## Bulletin: TAIB-0826

**Topic:** UltraShift® *PLUS* Product Enhancements

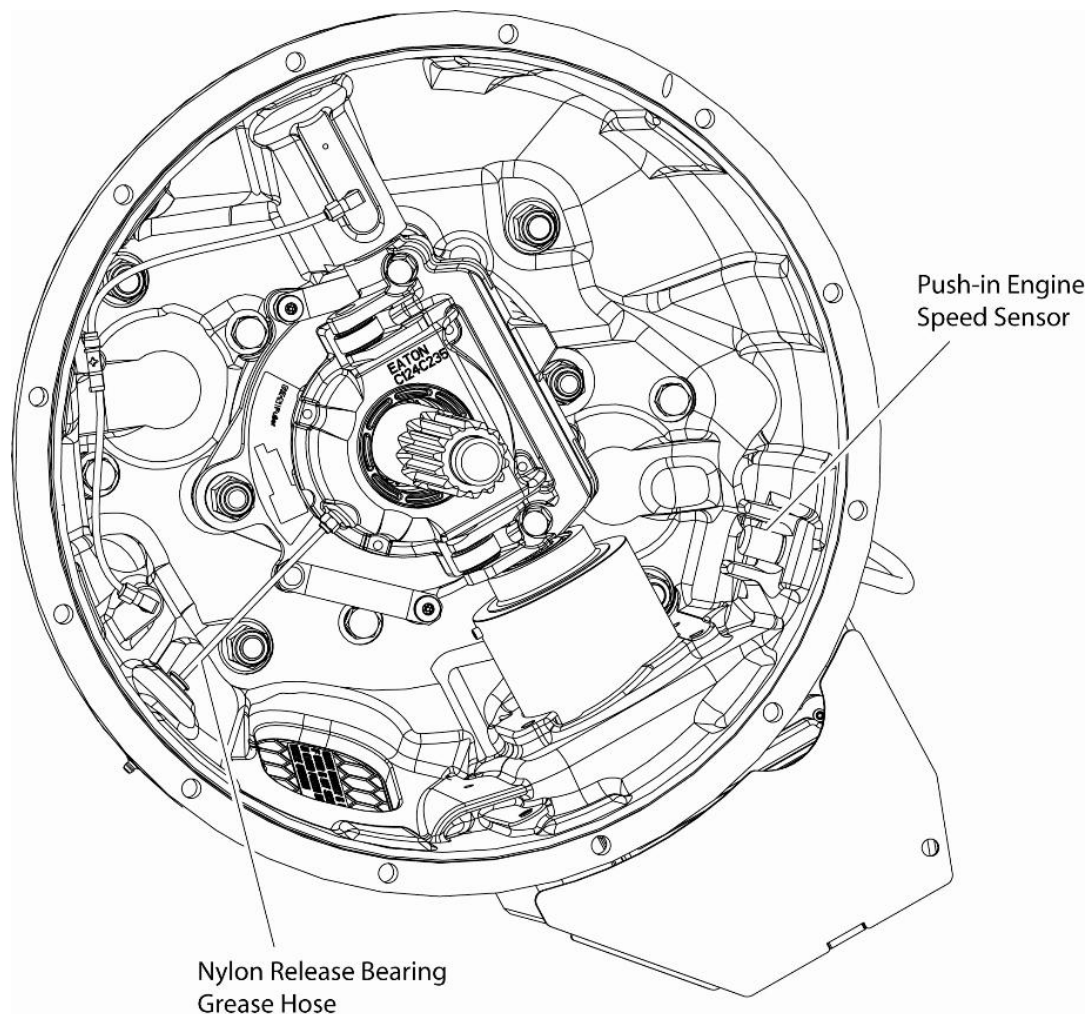
- A push-in engine speed sensor has been integrated into the clutch housing of all UltraShift *PLUS* transmissions and will replace the typical thread-in speed sensor previously installed by OEM's on the engine flywheel housing.
- A nylon release bearing grease tube has replaced the rubber hose design.
- The clutch housing is now machined to be compatible with the push-in engine speed sensor and the nylon release bearing grease tube.
- Transmission harness kits were modified to accommodate both the flywheel and clutch housing mounted speed sensor.

The New Style Clutch Housing contains provisions for the Nylon Release Bearing Grease Hose and the Push-in Engine Speed Sensor

Part Changes	Old Service Part / Kit	New Service Part / Kit	Servicing Old Style Models
Engine Speed Sensor	K-3776 Speed Sensor (thread-in)	K-3938 Speed Sensor (push-in)	Both kits available for purchase. Can still service old style units with K-3776
Release Bearing Grease Hose	K-3987 Hose Kit (rubber)	K-4037 Hose Kit (nylon)	Both kits available for purchase. Can still service old style units with K-3987
Complete Service Transmission	<i>Obsolete</i> Units using the Engine Flywheel Mounted Speed Sensor	<i>Replaced by</i> Units with the Clutch Housing Mounted Speed Sensor	Flywheel Speed Sensors are no longer needed in cases where a complete service unit is replacing and old style unit. The old Flywheel sensor can be left in place or replaced with an OEM supplied plug.
